Second Letter Report of Test Results of
USATECOM Project No. 8-3-0300-07 F, Product
Improvement Test of Armaltite AR-15 Rifle

UNITED STATES ARMY INFANTRY BOARD

14 OCT 1963

SUBJECT: Second Letter Report of Test Results of USATECOM Project No 8-3-0300-07 F, Product Improvement Test of Armalite AR-15 Rifle

TOP: Receiver of AR-15 rifle as tested in November 1962.
(No bolt assist device)

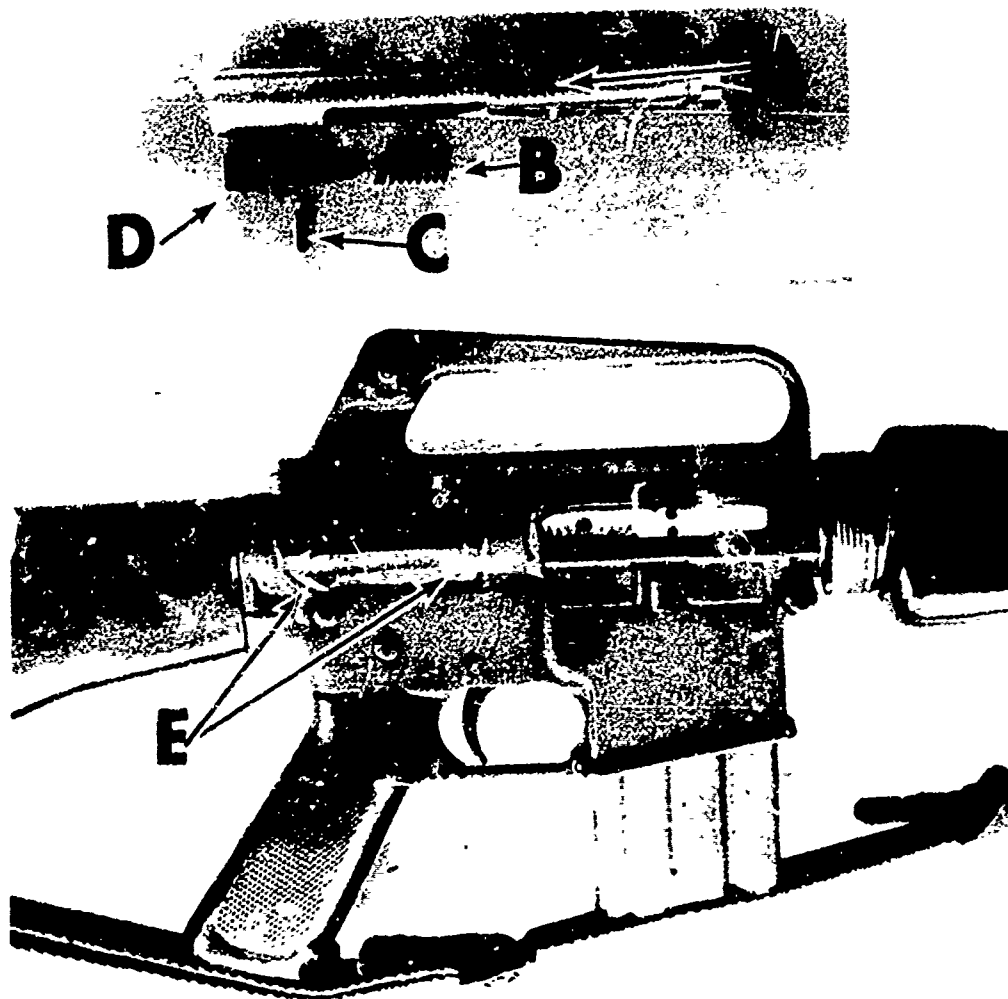
e. During the course of the firing and reloading exercises it was noted that the plunger cap was too small as it caused pain when struck with the heel of the hand (a human factors shortcoming).

b. The mounting of the bolt assist device on the left side of the receiver of the AR-15 rifle is not acceptable.

a. The bolt assist device, mounted on the right side of the receiver as tested, be considered acceptable for bolt closure when the striking surface of the plunger cap is increased in size to provide better striking area.
